TO: T10 Membership
FROM: Paul A. Suhler, Quantum Corporation
DATE: 26 April 2005
SUBJECT: T10/05-049r2, SSC-3 Physical Device Model

Figure X – UML description

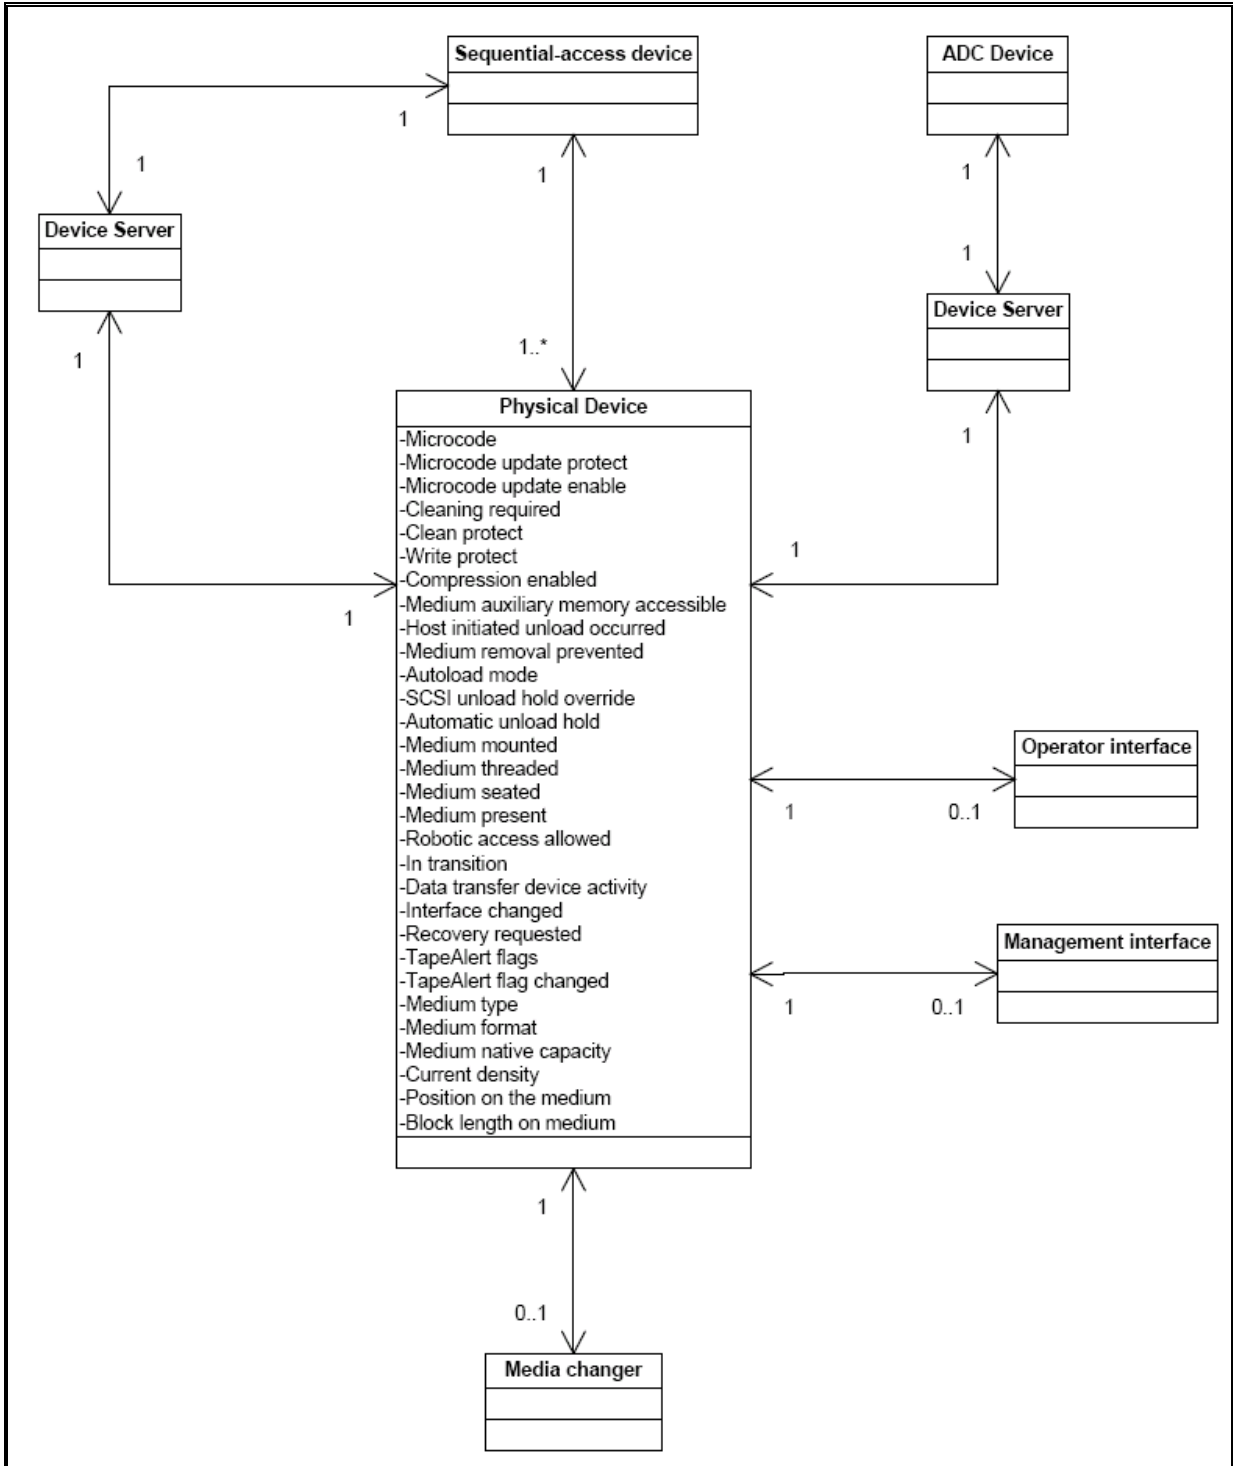
These entities perform operations that change various attributes of the physical device. These attributes affect the operations on a volume. Figure X shows in UML notation an example of the entities in a SCSI target device, and shows the attributes which comprise the physical device. The set of attributes implemented by a physical device is vendor-specific.
